TOWNSHIP OF KINGWOOD

Re: Docket CP15-558-000 – Proposed PennEast Pipeline Project
Draft EIS fails to address Ground Water Impacts

September 11, 2016

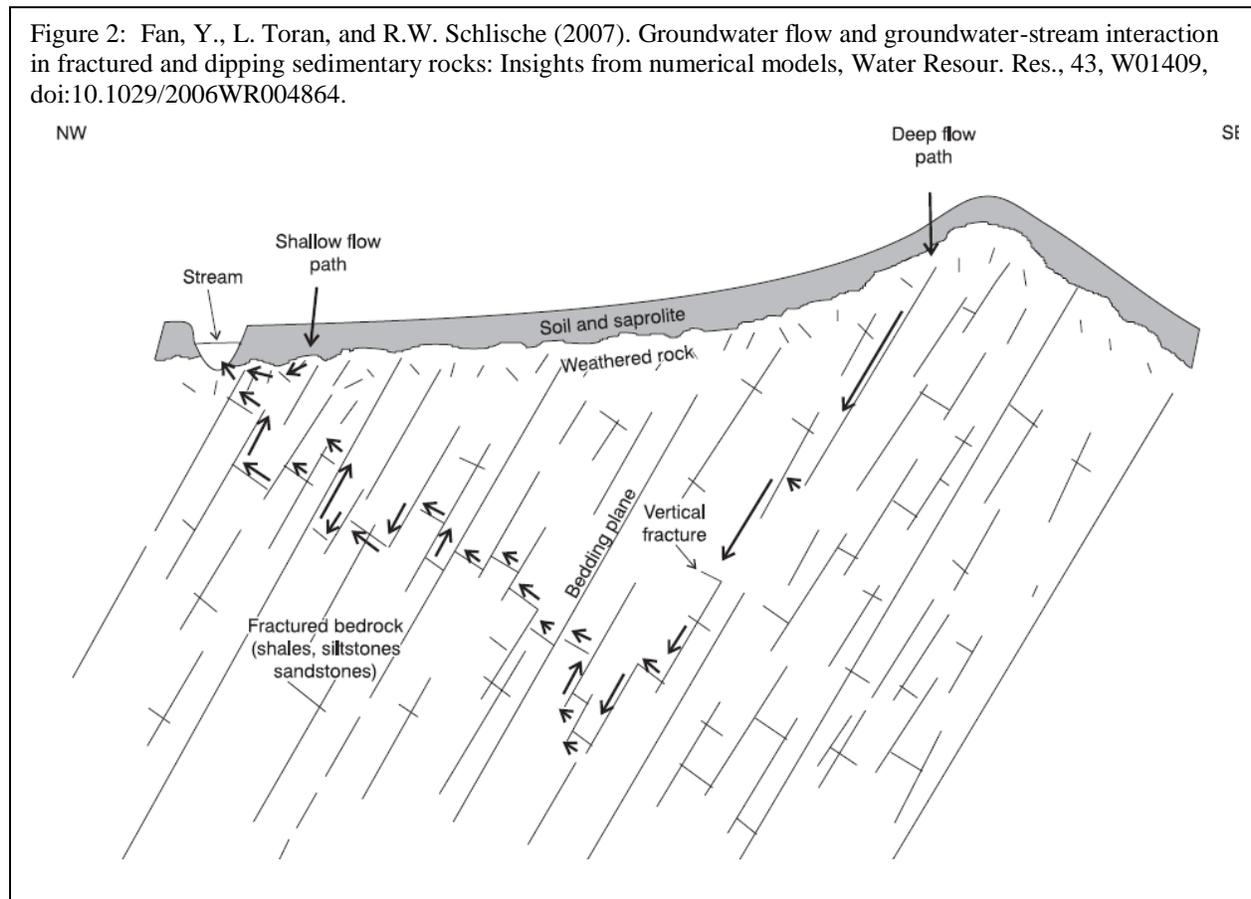
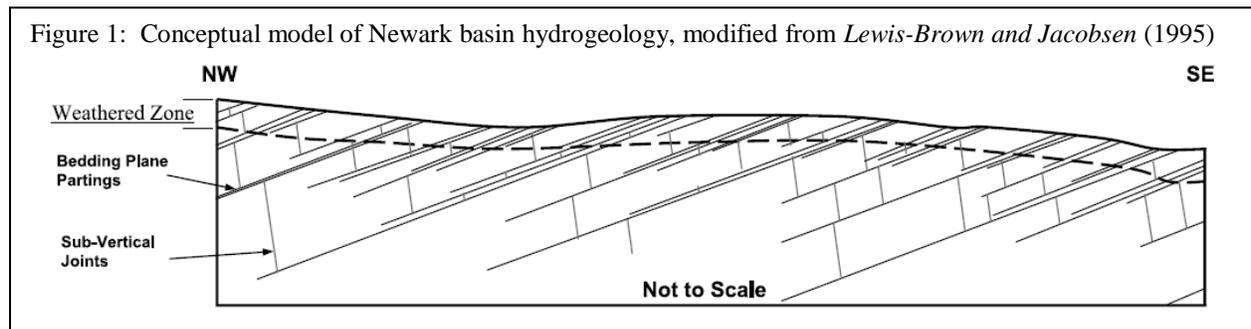
The discussion of the impact of excavating the 7-10 ft (~2-3 m) trench on ground water resources is misleading and indicates a lack of understanding of the local geology. Soil cover is thin and depth to bedrock can be as little as 1-2 meters. The soil is clayey with low permeability. The bedrock is a dense, impervious sedimentary rock (Passiac and Lockatong Formations) that is highly fractured (Figure 1). In

some localities a highly weathered zone (saprolite) occurs. Ground water originates as infiltration of local precipitation that percolates slowly through clayey soils (plus saprolite) and even more slowly through the tortuous pathway of bedrock fractures. Primary porosity, permeability and storage in this soil/rock system are very low resulting in observed high seasonal water table depths shallower than 1 meter. The ground water system drains slowly as it consists of dipping, layered fractured rocks where ground water flow is restricted to bedding planes. Vertical fractures do not cut extensively across beds, but may provide local routes between beds (Figure 2).
